Access Compliance Report

Public Rights-of-Way

(Curb Ramps)

Intersection ID: 6957	Main Street: N_TRYON_ST	Cross Street: N_US_29_BY-PASS_HY	Location: E
ADA ID: 9C9E972E69A2	Ramp Type: Perp	Initial Pass/Fail: Fail	Overall Compliance: No
Severity Score: 8.75			
Codes/Mitigation Info/Possible Solution		Field Measurements/Component Compliance

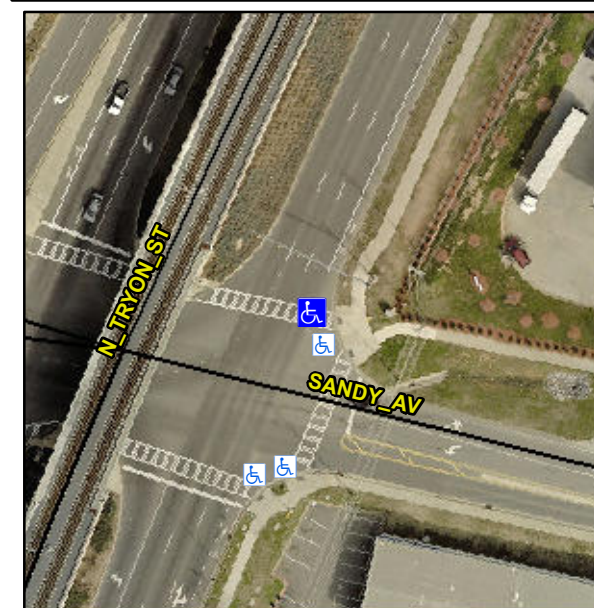
Not Found, R304.5.1

Compliance	Description	Data	Compliance	Description	Data
N/A	Ramp Length (in)	102.0	Yes	Ramp Slope (%)	6.2
No	Ramp Width (in)	46.0	Yes	Ramp XSlope (%)	1.6
N/A	Flare Type LT	N/A	N/A	Flare Type RT	N/A
N/A	Flare Slope LT (%)	N/A	N/A	Flare Slope RT (%)	N/A
N/A	Flare Traversable LT?	N/A	N/A	Flare Traversable RT?	N/A
N/A	Landing Length (in)	N/A	N/A	DWS Provided?	N/A
N/A	Landing Width (in)	N/A	N/A	DWS Contrast?	N/A
N/A	Landing Slope (%)	N/A	N/A	DWS Length (in)	N/A
N/A	Landing X Slope (%)	N/A	N/A	DWS Full Width?	N/A
N/A	Landing Curb? (Y/N)	N/A	N/A	DWS Offset (in)	N/A
N/A	Shared Landing?	N/A			
N/A	Gutter Ponding?	N/A	N/A	Gutter Slope (%)	N/A
N/A	Gutter Lip Ht (in)	1.5	N/A	Gutter X Slope (%)	N/A
N/A	Painted X Walk1?	Yes	N/A	Painted X Walk2?	N/A
	X Walk 1 Direction	To NW		X Walk 2 Direction	N/A
N/A	X Walk 1 Width (in)	111.0	N/A	X Walk 2 Width (in)	N/A
	X Walk 1 Slope (%)	5.5		X Walk 2 Slope (%)	N/A
	X Walk 1 X Slope (%)	1.0		X Walk 2 X Slope (%)	N/A

Remove & Replace Entire Ramp.
